TARMAC KING ROAD
LIMESTONE MINE
LEVY COUNTY, FLORIDA

Second Request for Additional Information Response

File Number 0244771-002

Re: **Request for Additional Information 2**
Tarmac America – Titan King Road Mine
File No. 0244771-002, Levy County

TYPICAL LAKE MINING SECTION

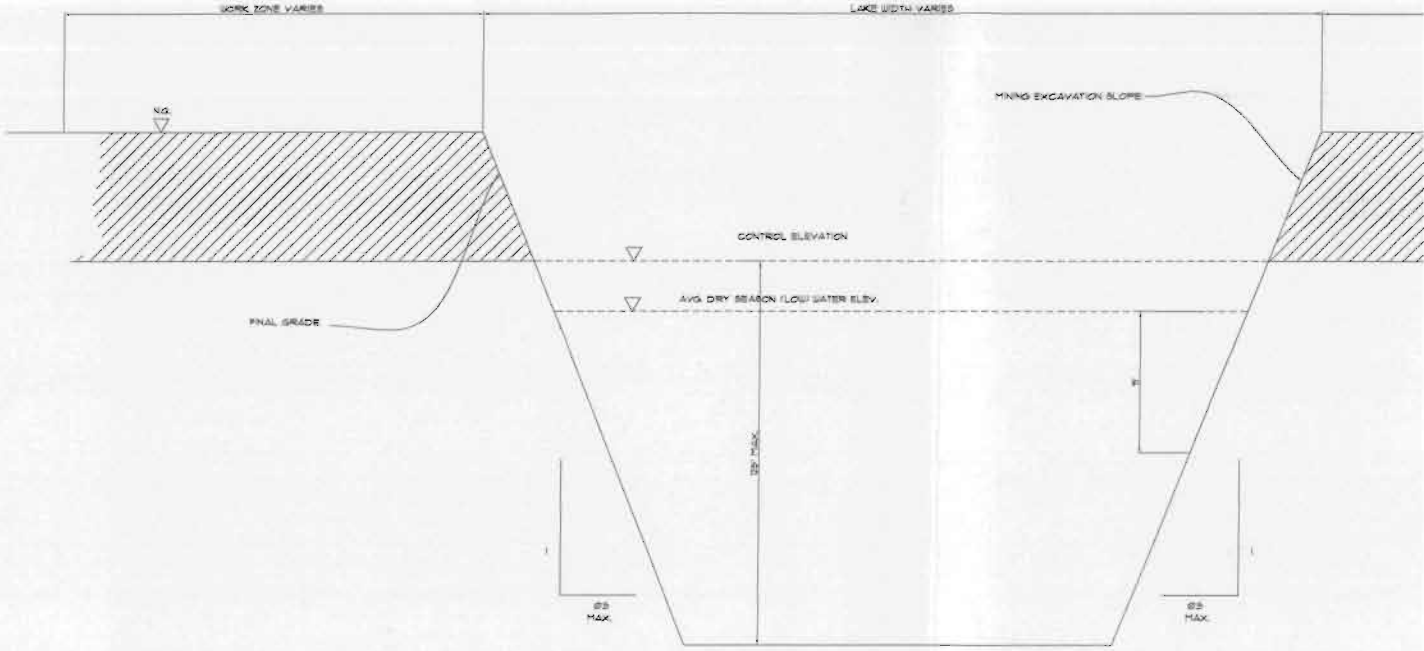
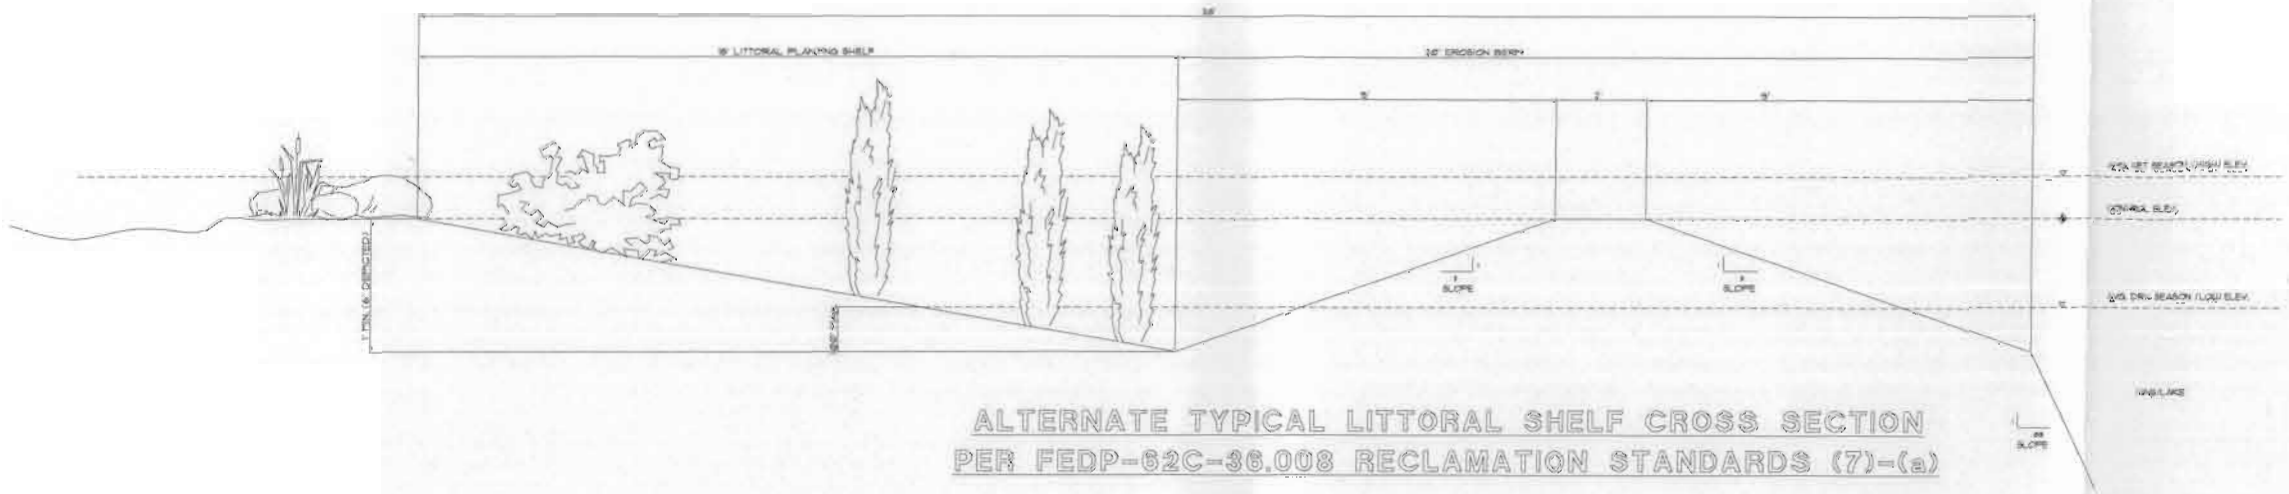
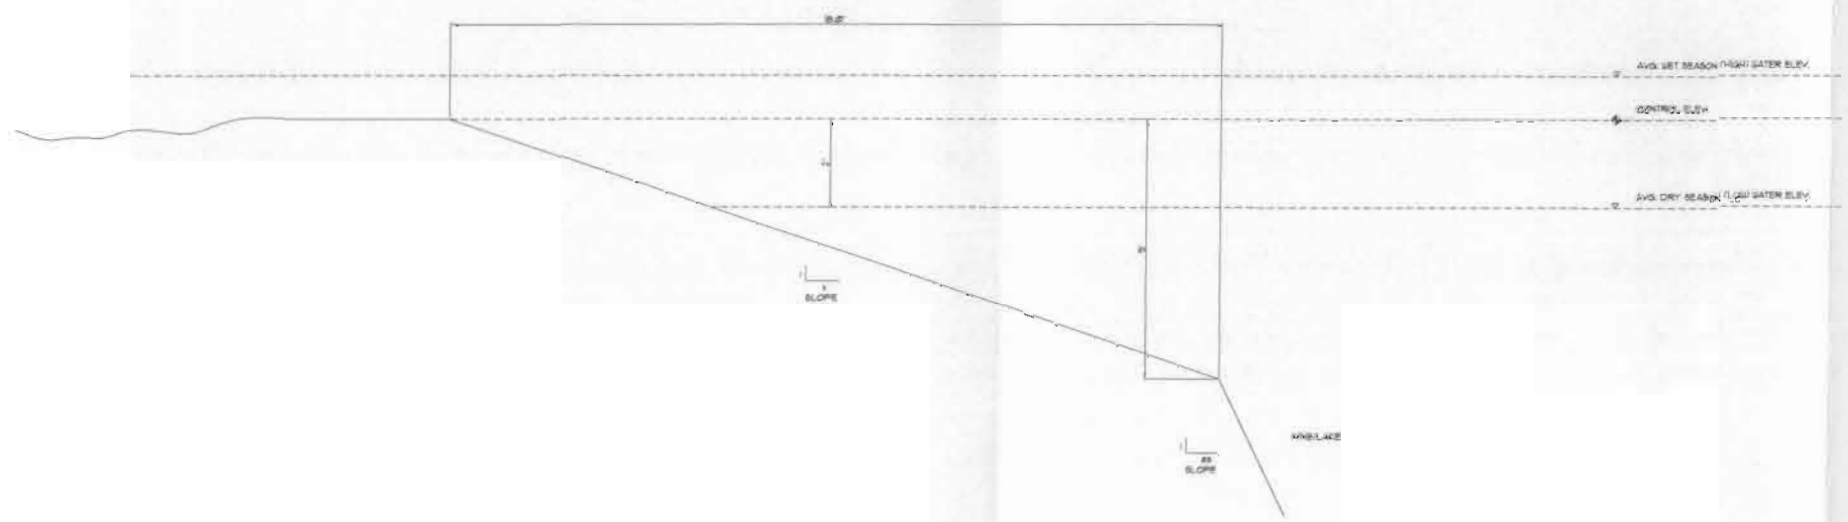
DEP 19. *The section H, "Typical Final Mineout Section", sheet D4 of 4 does not meet the reclamation performance standards of Chapter 62C-36, F.A.C.*

Response: **Please see revised Sheet D4 of Attachment 5, Engineering Drawings.**
